Florida
Floats, Inc.
dba Bellingham Marine

January 13, 2014

Re: Ft. Pierce City Marina- RFP No. 2013-021

Per our meeting on Monday December 30, 2013, I have reviewed and made the corrections listed below in items 1-7.

**FT. PIERCE MARINA
 ST. LUCIE COUNTY, FL.
 LAYOUT**

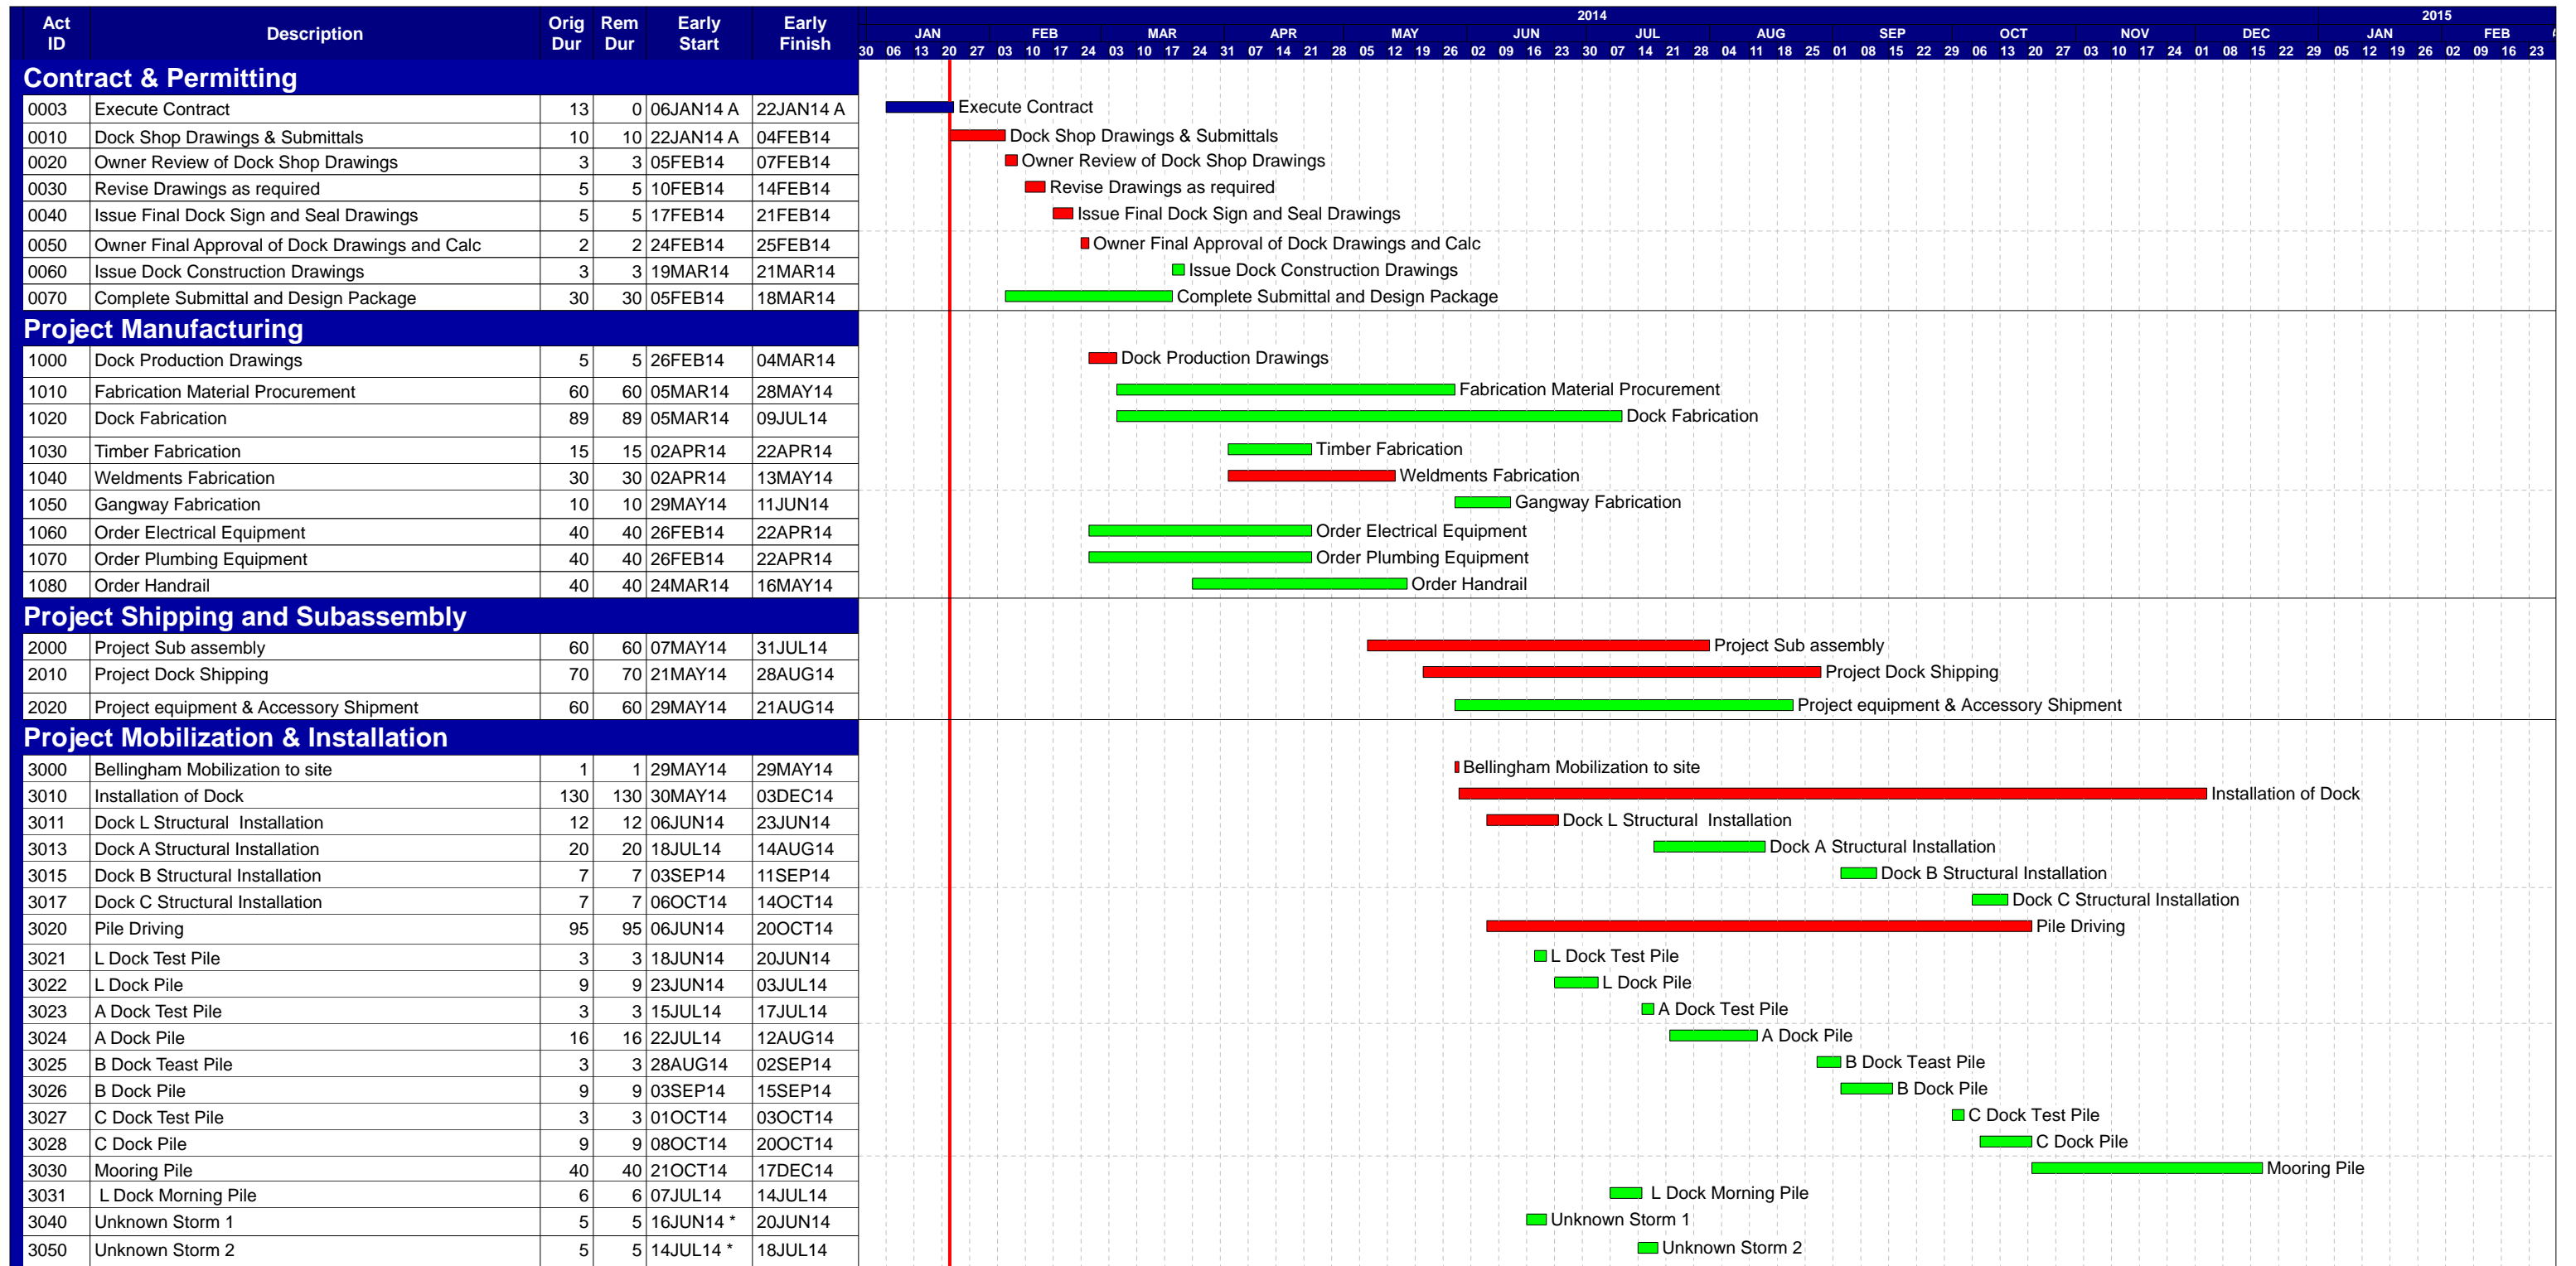
- ~~3. Cross Over Trench, as highlighted 25 ea. (Attachment C)..... \$6,583.00~~
Delete Item
4. The schedule has been revised to reflect the execution of the contract on January 22, 2014. I have broken out the docks to sequence L Dock start then moving to A Dock. (Attachment D)

= Cross over trench
As used on Stock Island maring Key West.
